Rule 6 Party: Saffron Walden Town Council & Swards End Parish Council

LPA REF: UTT/21/2509/OP PINS REF: APP/C1570/W/22/3296426

RESPONSE TO CONSULTATION FOR MITIGATION PROPOSALS AT JUNCTION 4

Impact on Chaters Hill Bridge and attached walls

Figure 3 (far left)

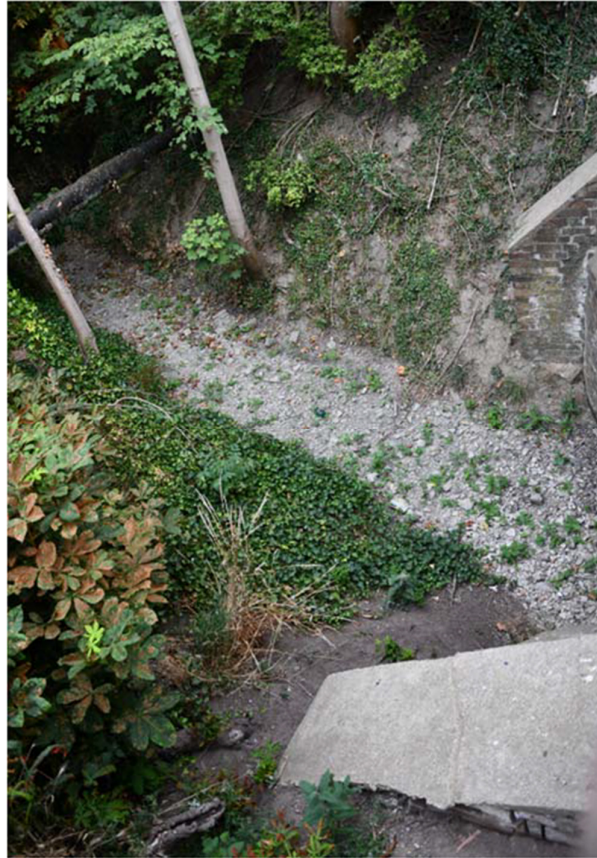
The Bridge is over the Kings Ditch section of the Slade and the visible structure dates from c1800 and later. It is of red brick, with flint and brick parapet and attached walls. The Slade ditches are a significant part of the planned medieval town of Saffron Walden and it is also likely that there is an earlier core to this bridge. Stylistically, the western archway dates from approximately 1805.

Bridge elevation facing west (c1800).
From the Common.
